UNITED STATES
NUCLEAR REGULATORY COMMISSION
WASHINGTON, D.C. 20555-0001

SUBJECT: COLUMBIA GENERATING STATION - ISSUANCE OF AMENDMENT NO. 268
TO REVISE TECHNICAL SPECIFICATION 3.4.11 "RCS PRESSURE AND
TEMPERATURE (P/T) LIMITS" (EPID L-2021-LLA-0191)

SAFETY EVALUATION BY THE OFFICE OF NUCLEAR REACTOR REGULATION

COLUMBIA GENERATING STATION

Figure 3.4.11-1 (page 1 of 1)
Inservice Leak and Hydrostatic Testing Curve

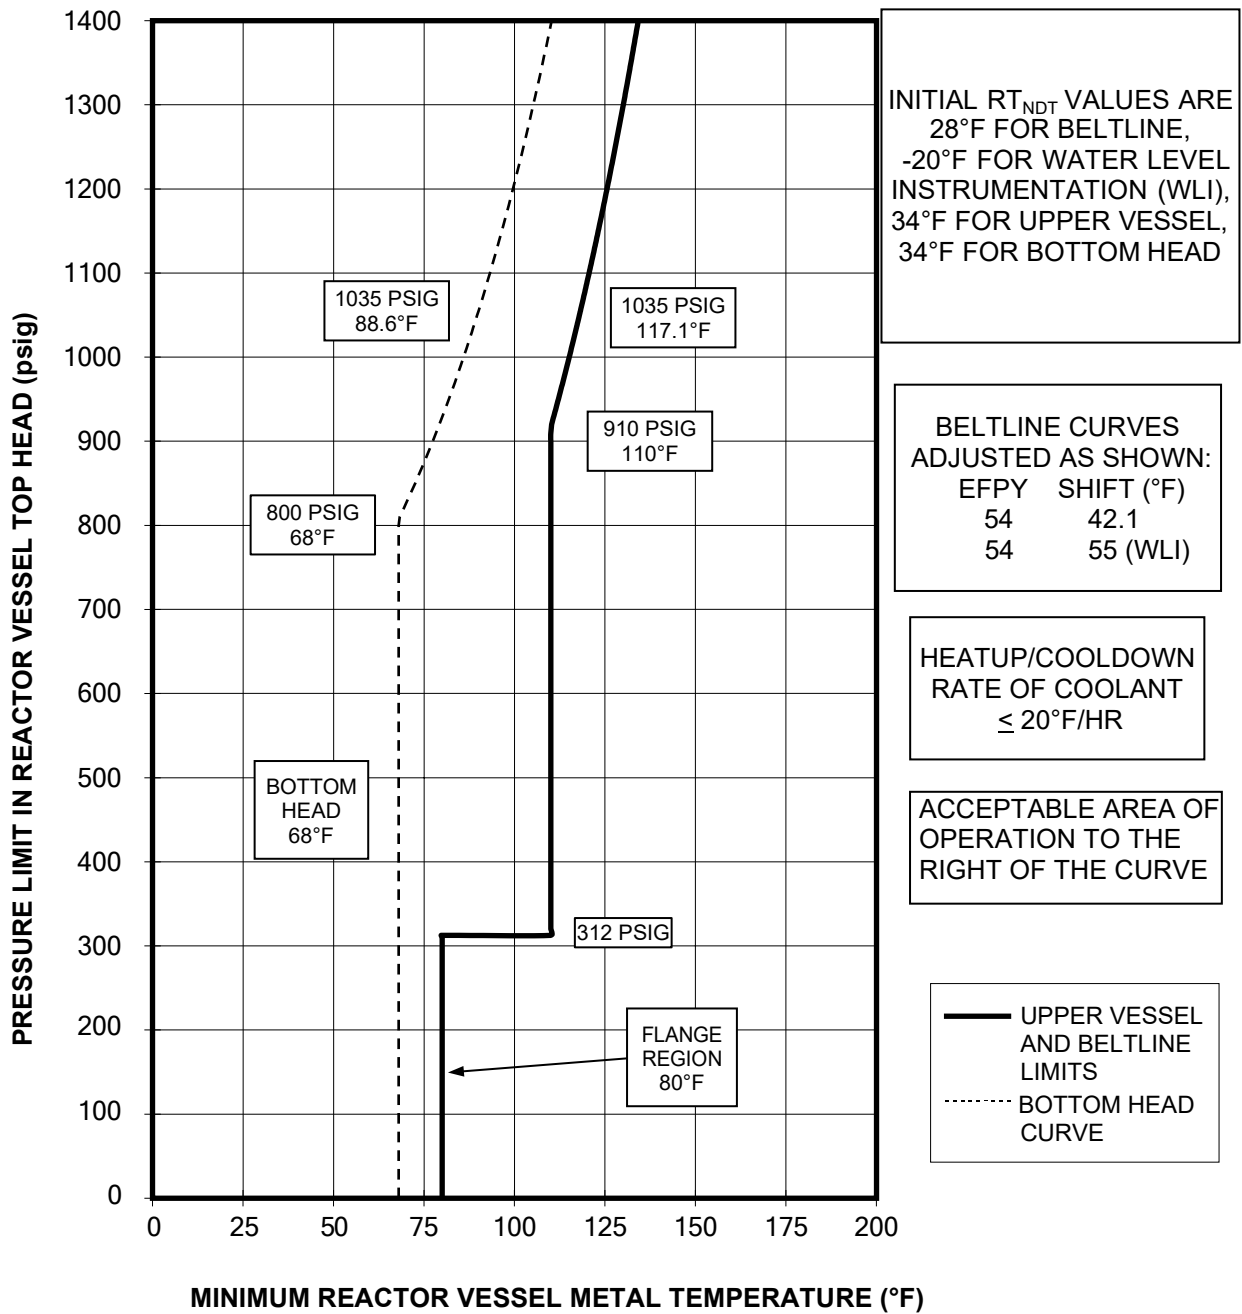
The NRC staff determined that proposed Curve A in TS figure 3.4.11-1 for the inservice leak and hydrostatic testing is based on a temperature rate of less than or equal to (\leq) 20 °F/hour. As such, the thermal stress is considered negligible. Therefore, the licensee set the K_{It} to zero in the fracture mechanics calculation. The NRC staff finds acceptable that the K_{It} is zero because temperature gradient in the RPV shell wall is too small to generate any significant thermal stresses during the hydrostatic and leakage tests. The NRC staff determined that licensee appropriately set the safety factor for the K_{Im} to 1.5 in accordance with the requirements of the ASME Code, Section XI, Appendix G.

Appendix G to 10 CFR Part 50, Table 1, item 1.a, requires that when the operating pressure is \leq 20 percent of the preservice system hydrostatic test pressure, the minimum temperature on the P/T curve must be the highest reference temperature of the material in the closure flange region that is highly stressed by the bolt preload. The NRC staff confirmed that the preservice system hydrostatic test pressure used in the licensee's proposed P/T curve calculation is consistent with P/T curves in other BWR plants and consistent with the requirements of 10 CFR 50, Appendix G and guidance of SRP 5.3.2 and therefore is acceptable. The NRC staff verified that the proposed Curve A in TS figure 3.4.11-1 satisfies 10 CFR Part 50, Appendix G, Table 1, item 1.a.

Appendix G to 10 CFR Part 50, Table 1, item 1.b, requires that when the pressure is greater than ($>$) 20 percent of the preservice system hydrostatic test pressure, the minimum temperature on the P/T curve must be the highest reference temperature of the material in the closure flange region that is highly stressed by the bolt preload plus 90 °F. The item 1.b requirement creates a bend (a knee) in the non-beltline P/T curve at 312.6 pounds per square inch gauge (psig) because the closure flange is part of the non-beltline region. The NRC staff verified that the proposed Curve A of TS figure 3.4.11-1 satisfies 10 CFR Part 50, Appendix G, Table 1, item 1.b. Therefore, the NRC staff finds proposed Curve A in TS figure 3.4.11-1 acceptable because it satisfies the requirements of items 1.a and 1.b of 10 CFR Part 50, Appendix G, Table 1 and the ASME Code, Section XI, appendix G.

Figure 3.4.11-2 (page 1 of 1)
Non-Nuclear Heating and Cooldown Curve

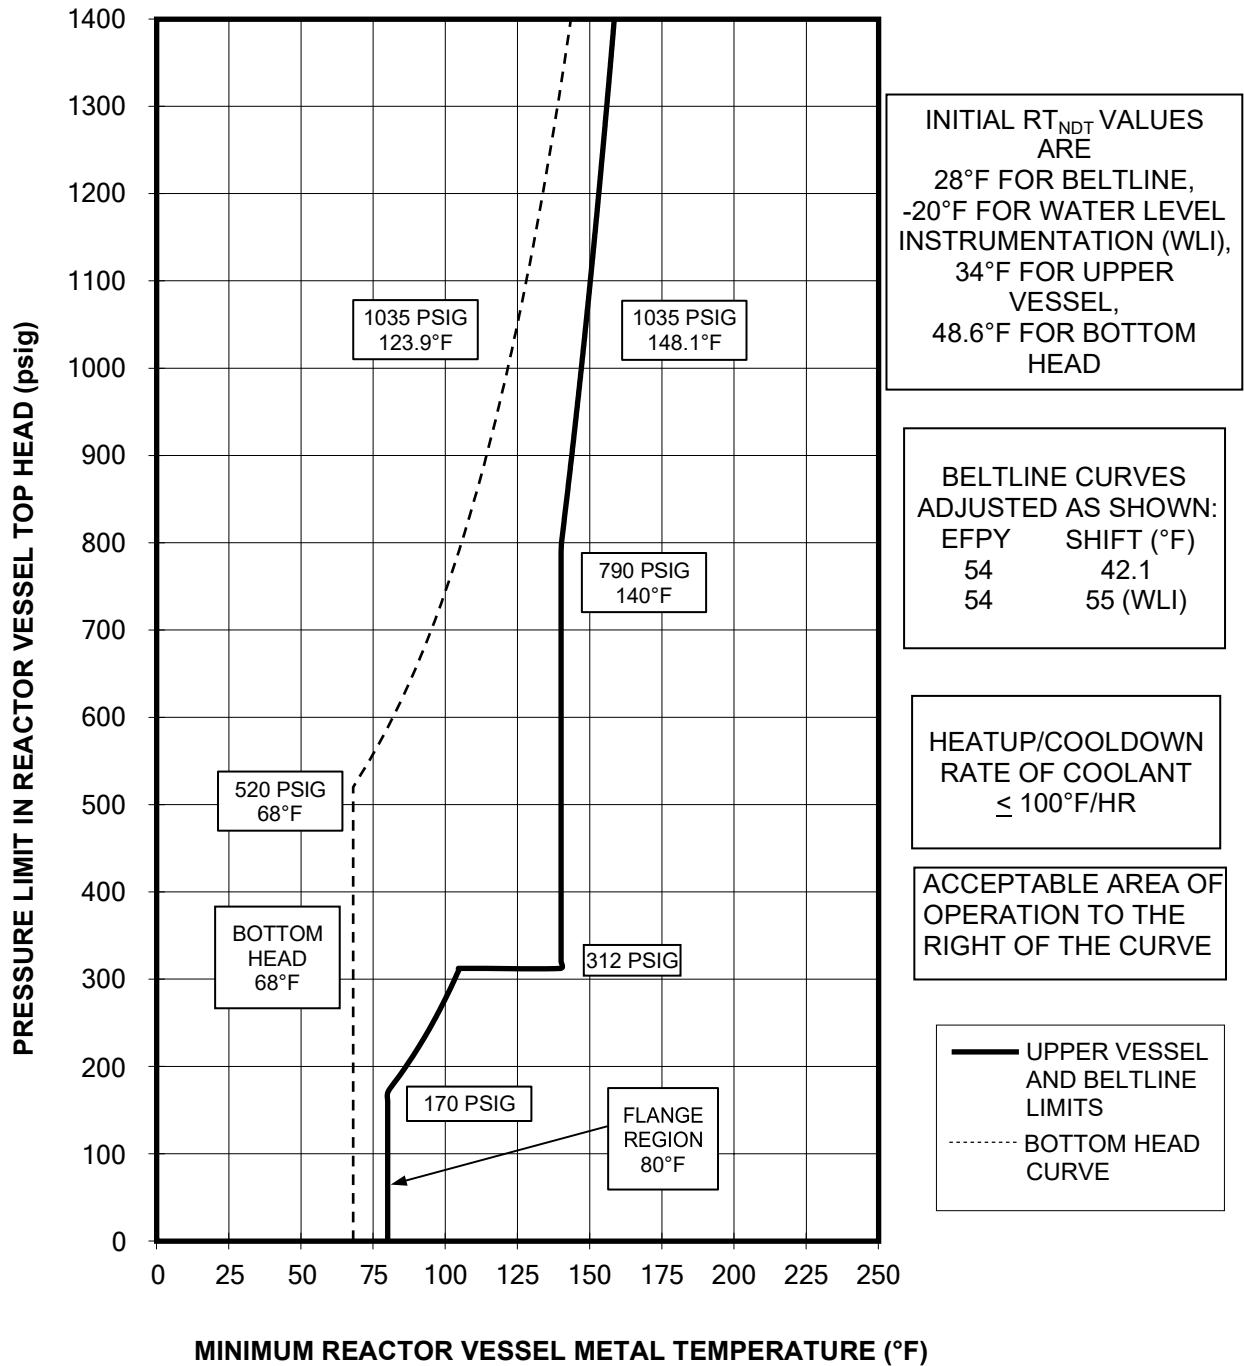
The NRC staff notes that the initial RT_{NDT} for the bottom head in proposed TS figure 3.4.11-2 is higher than that of proposed TS figures 3.4.11-1 and 3.4.11-3. In its July 11, 2022, letter, the licensee explained that a higher temperature was used for the initial RT_{NDT} of the bottom head in proposed TS figure 3.4.11-2 to provide additional operational flexibility because of emergent events. The NRC staff determined that the initial RT_{NDT} temperature is acceptable for the initial RT_{NDT} for the bottom head in TS figure 3.4.11-2 because the higher temperature used for the RT_{NDT} provides operational flexibility.

The NRC staff determined that Curve B in TS figure 3.4.11-2 is applicable during times when the coolant heatup or cooldown rate is greater than 20 °F/hour during a pressure test and when the core is not critical. Additionally, Curve B must be followed when performing low-power physics testing. The heatup and cooldown rate is limited to \leq 100 °F/hour when using Curve B.

The NRC staff verified that in accordance with the ASME Code, Section XI, appendix G to construct proposed Curve B, the licensee used the safety factors of 2.0 and 1.0 for the K_{Im} and K_{It} , respectively.

Appendix G to 10 CFR Part 50, Table 1, item 2.a requires that when the operating pressure is ≤ 20 percent of the preservice system hydrostatic test pressure, the minimum temperature must be the highest reference temperature of the material in the closure flange region that is highly stressed by the bolt preload. The NRC staff verified that the proposed Curve B in TS figure 3.4.11-2 satisfies item 2.a.

Appendix G to 10 CFR Part 50, Table 1, item 2.b, requires that when the operating pressure is > 20 percent of the preservice system hydrostatic test pressure, the minimum temperature must be the highest reference temperature of the material in the closure flange region that is highly stressed by the bolt preload plus 120 °F. The item 2.b requirement creates a bend for the non-beltline P/T curve at 312.6 psig because the closure flange is part of the non-beltline region. The NRC staff verified that the proposed Curve B in TS figure 3.4.11-2 satisfies item 2.b.

Therefore, the NRC staff finds proposed Curve B in TS figure 3.4.11-2 acceptable because it satisfies the requirements of items 2.a and 2.b in 10 CFR Part 50, Appendix G, Table 1 and the ASME Code, Section XI, appendix G.

Figure 3.4.11-3 (page 1 of 1)
Nuclear Heating and Cooldown Curve

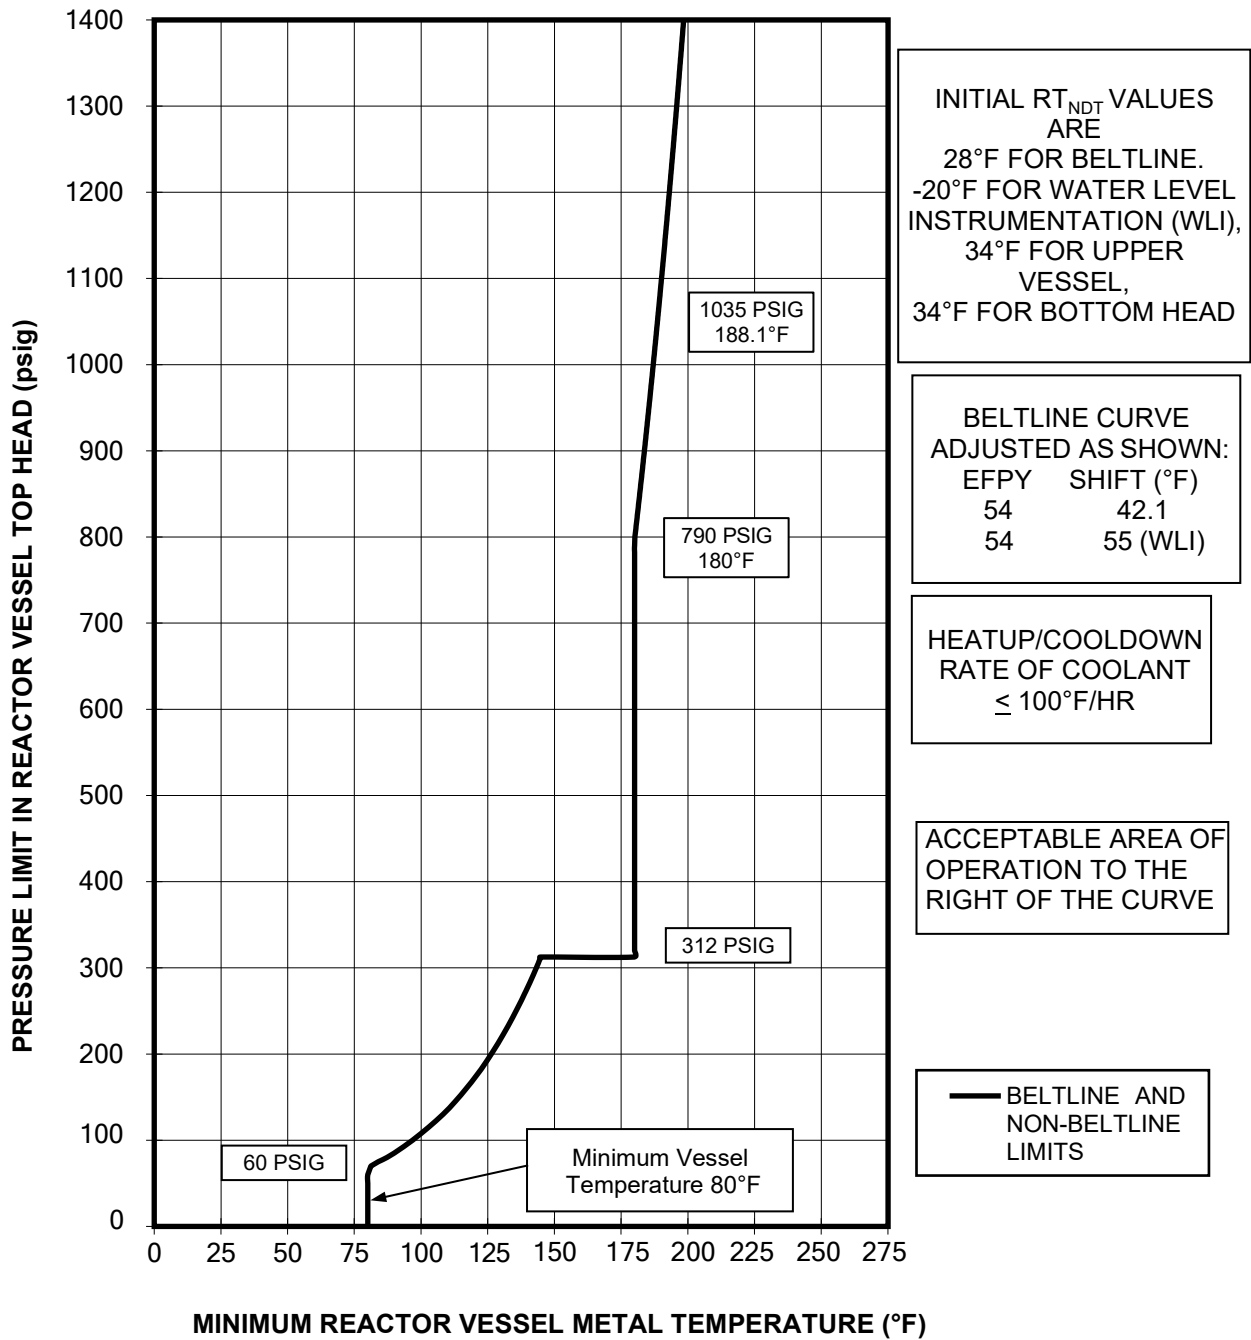
The NRC staff determined that the proposed Curve C in TS figure 3.4.11-3 is used when the core is critical with the exception during low-power physics testing activities. The heatup and cooldown rate is limited to ≤ 100 °F/hour when using proposed Curve C. The NRC staff verified that in accordance with the ASME Code, Section XI, appendix G to construct proposed Curve C, the licensee used the safety factor of 2.0 and 1.0 for the K_{Im} and K_{It} , respectively.

Appendix G to 10 CFR Part 50, Table 1, items 2.c, 2.d, and 2.e require that the P/T curve for the core critical condition (i.e., Curve C) be 40 °F greater than the P/T curves for the core not critical (i.e., Curve B) under all operating pressure conditions. The NRC staff verified that proposed Curve C is 40 °F greater than proposed Curve B and that the proposed Curve C in TS figure 3.4.11-3 satisfies the 40 °F requirement of items 2.c, 2.d, and 2.e.

Regarding the minimum temperature requirement, Appendix G to 10 CFR Part 50, Table 1, item 2.c requires that when the operating pressure is ≤ 20 percent of the preservice system hydrostatic test pressure, the minimum temperature must be larger of the minimum permissible temperature for the inservice system hydrostatic pressure test or the closure flange RT_{NDT} plus 40 °F. The NRC staff verified that the proposed Curve C in TS figure 3.4.11-3 satisfies item 2.c.

Appendix G to 10 CFR Part 50, Table 1, item 2.d requires that when the reactor internal pressure is > 20 percent of the preservice system hydrostatic test pressure, the minimum temperature must be larger of the minimum permissible temperature for the inservice system hydrostatic pressure test or closure flange RT_{NDT} plus 160 °F. The NRC staff finds that the notch exists in proposed Curve C at 312.6 psig and item 2.d requirement is satisfied.

Appendix G to 10 CFR Part 50, Table 1, item 2.e requires that for BWRs, 60 °F be added to the highest reference temperature of the material in the closure flange region that is highly stressed by the bolt preload when the operating pressure is less than ($<$) 20 percent of preservice system

hydrostatic test pressure. The NRC staff verified that the proposed Curve C in TS figure 3.4.11-3 satisfies item 2.e.

The NRC staff finds proposed Curve C in TS figure 3.4.11-3 acceptable because it satisfies the requirements of sections IV.2.c, IV.2.d, and IV.2.e of 10 CFR Part 50, Appendix G, Table 1 and the ASME Code, Section XI, Appendix G.
